APPLICATION NO.	FILING DATE	FIRST NAMED INVENTOR	ATTORNEY DOCKET NO.	CONFIRMATION NO.
10/698,969	10/31/2003	Dimiter S. Zagoroff	3567.1001-000	8813

Office Action Summary

DETAILED ACTION

Application No.: 10/698,969
Title: Method and Apparatus for Remote...
Inventor: Dimiter S. Zagoroff
Replacement Sheet

Fig. 6A

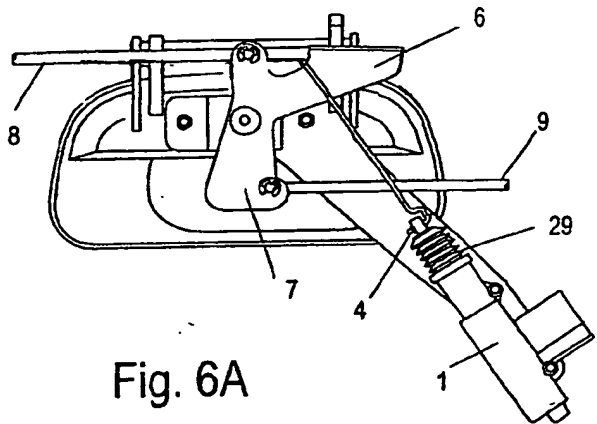
FIG. 6A
approved
D/S
2/23/05
